**Revisions and Errata List**  
**AISC Steel Design Guide 11, 2<sup>nd</sup> Edition, 1<sup>st</sup> printing (Printed and Digital Editions)**  
**February 16, 2023**

The following list represents corrections made to the first printing (dated May 2016) and digital edition of the second edition of AISC Design Guide 11, *Vibrations of Steel-Framed Structural Systems Due to Human Activity*.

Fig. 7-17. Predicted FRF magnitudes, Example 7.2.

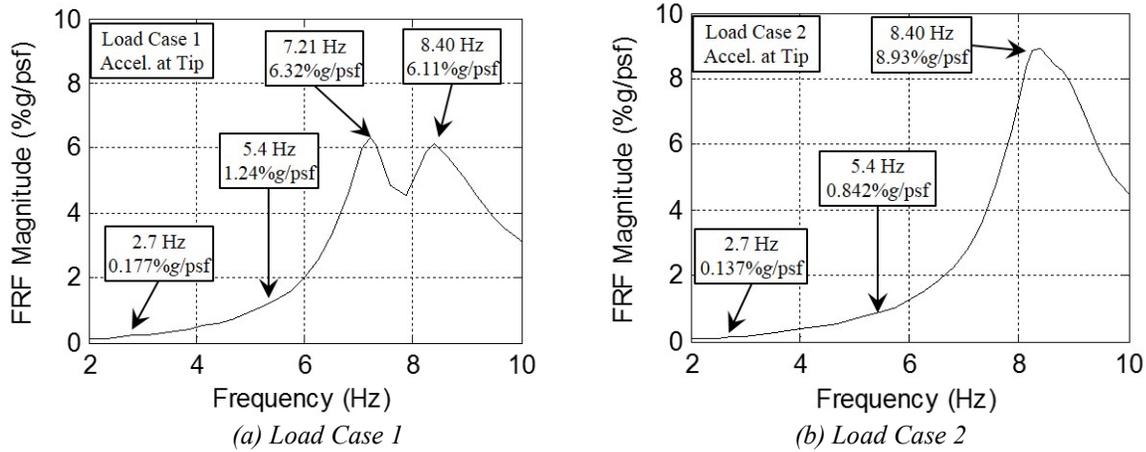
Replace Figure 7-17 with the following:
